10/581,415

Office Action Summary	Application No. 10/581,415	Applicant(s) MAIER ET AL.	
	Examiner MACADE BROWN	Art Unit 3753

DETAILED ACTION

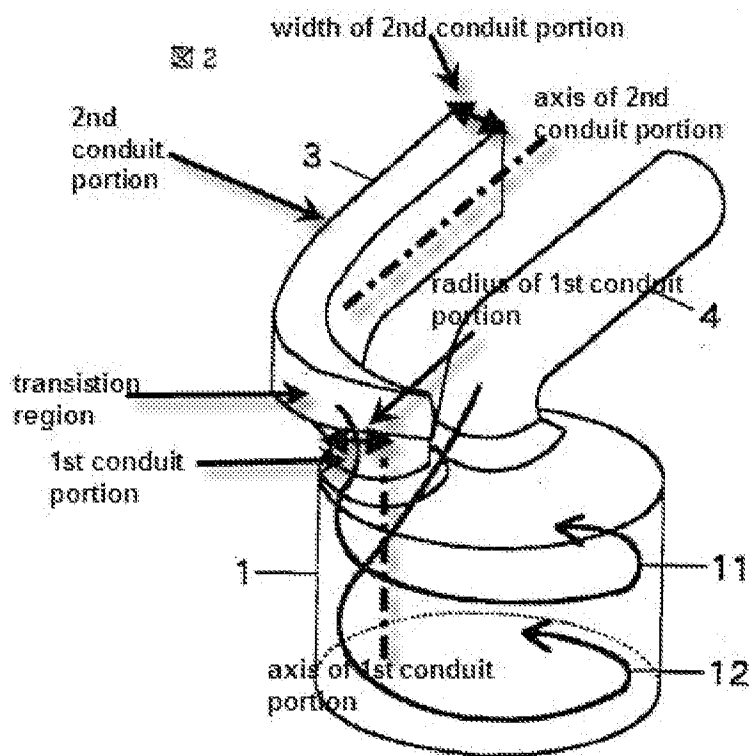
Nakakita teaches a fluid conduit 3 (fig. 2) with a substantially constant width and embodied such that a swirl-type rotation about the longitudinal axis of the fluid conduit is impressed on the fluid stream that flows toward the chamber 1, without a constriction of this fluid stream being produced by the conduit in the production of the swirl-type rotation of the fluid, (note: it has been held that a recitation with respect to the manner in which a claimed apparatus is intended to be employed, i.e. "so that the swirl-type rotation of the fluid results in improved efficiency," does not differentiate the claimed apparatus from a prior art apparatus satisfying the claimed structural limitations); the fluid conduit 3 includes a first conduit portion and a second conduit portion adjoining the first conduit portion (see fig. 2 below), the longitudinal axes of the first and second conduit portion being at an angle < 180 degrees to one another, and the longitudinal axis of the first conduit portion being laterally offset from the longitudinal axis of the second conduit portion; the longitudinal axes of the first and second conduit portions being at least approximately at a right angle to one another (see fig. 2 below); the first and second conduit portions, in cross section, have at least approximately the same radius (the width of the second conduit portion is approximately equal to the radius of the first conduit portion); further including a transition region (see fig. 2 below); further including

a transition region (see fig. 2 below) between the first conduit portion and the second conduit portion; the first conduit portion extends no more than a very small distance past the second conduit portion; the transition region including a wall that is curved from the first conduit portion to the second conduit portion; the first conduit portion and second conduit portion form an angle > 90 degree, to produce a swirl flow of the gas.

It would have been obvious to one of ordinary skill in the art, at the time of invention, to employ in applicant's admitted prior art a fluid conduit embodied such that a swirl-type rotation about the longitudinal axis of the fluid conduit is impressed on the fluid stream that flows toward the valve chamber, without a constriction of this fluid stream being produced by the conduit in the production of the swirl-type rotation of the fluid; the fluid conduit includes a first conduit portion and a second conduit portion

adjoining the first conduit portion, the longitudinal axes of the first and second conduit portion being at an angle < 180 degrees to one another, and the longitudinal axis of the first conduit portion being laterally offset from the longitudinal axis of the second conduit portion; the longitudinal axes of the first and second conduit portions being at least approximately at a right angle to one another; the first and second conduit portions, in cross section, have at least approximately the same radius; further including a transition region between the first conduit portion and the second conduit portion; the first conduit portion extends no more than a very small distance past the second conduit portion; the first conduit portion and second conduit portion form an angle > 90 degrees, as taught by Nakakita, for the purpose of producing a swirl flow of the fluid, which would result in minimizing turbulent flow of the fluid.

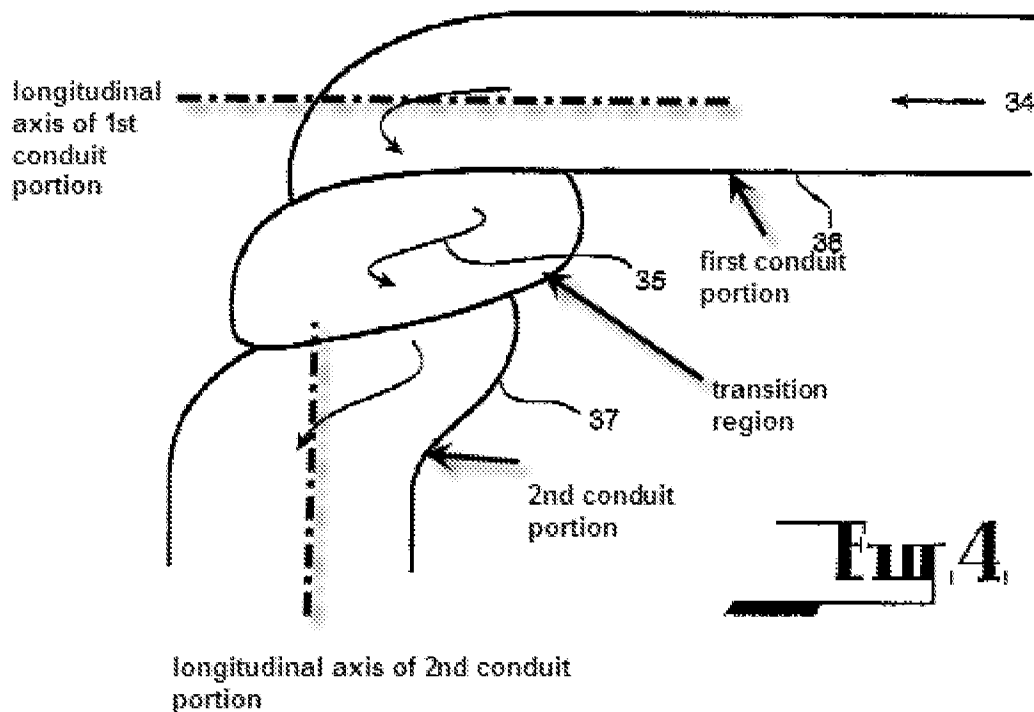
Harman teaches a fluid conduit 36 (fig. 4) having a substantially constant width and embodied such that a swirl-type rotation about the longitudinal axis of the fluid conduit is impressed on the fluid stream that flows out, without a constriction of this fluid stream being produced by the conduit in the production of the swirl-type rotation of the fluid, (note: it has been held that a recitation with respect to the manner in which a claimed apparatus is intended to be employed, i.e. "so that the swirl-type rotation of the fluid results in improved efficiency," does not differentiate the claimed apparatus from a prior art apparatus satisfying the claimed structural limitations); the fluid conduit 36 comprises a first conduit portion and a second conduit portion adjoining the first conduit portion (see fig. 4 below), the longitudinal axes of the first and second conduit portion being at an angle <180 degrees to one another, and the longitudinal axis of the first conduit portion being laterally offset from the longitudinal axis of the second conduit portion; the longitudinal axes of the first and second conduit portions being at least approximately at a right angle to one another (see fig. 4 below); the first and second conduit portions, in cross section, have at least approximately the same radius; further including a transition region between the first conduit portion and the second conduit portion (see fig. 4 below); the transition region including a wall that is curved from the first conduit portion to the second conduit portion; the first conduit portion extends no more than a very small distance past the second conduit portion, to reduce the degree of extraneous turbulence (pg. 1, lines 22-23).

It would have been obvious to one of ordinary skill in the art, at the time of invention, to employ in applicant's admitted prior art a fluid conduit with a substantially constant width and embodied such that a swirl-type rotation about the longitudinal axis of the fluid conduit is impressed on the fluid stream that flows toward the valve chamber, without a constriction of this fluid stream being produced by the conduit in the production of the swirl-type rotation of the fluid; the fluid conduit includes a first conduit portion and a second conduit portion adjoining the first conduit portion, the longitudinal axes of the first and second conduit portion being at an angle < 180 degrees to one another, and the longitudinal axis of the first conduit portion being laterally offset from the longitudinal axis of the second conduit portion; the longitudinal axes of the first and second conduit portions being at least approximately at a right angle to one another; the first and second conduit portions, in cross section, have at least approximately the same

radius; further including a transition region; the transition region including a wall that is curved from the first conduit portion to the second conduit portion; the first conduit portion extends no more than a very small distance past the second conduit portion, as taught by Harman, for the purpose of reducing turbulence.
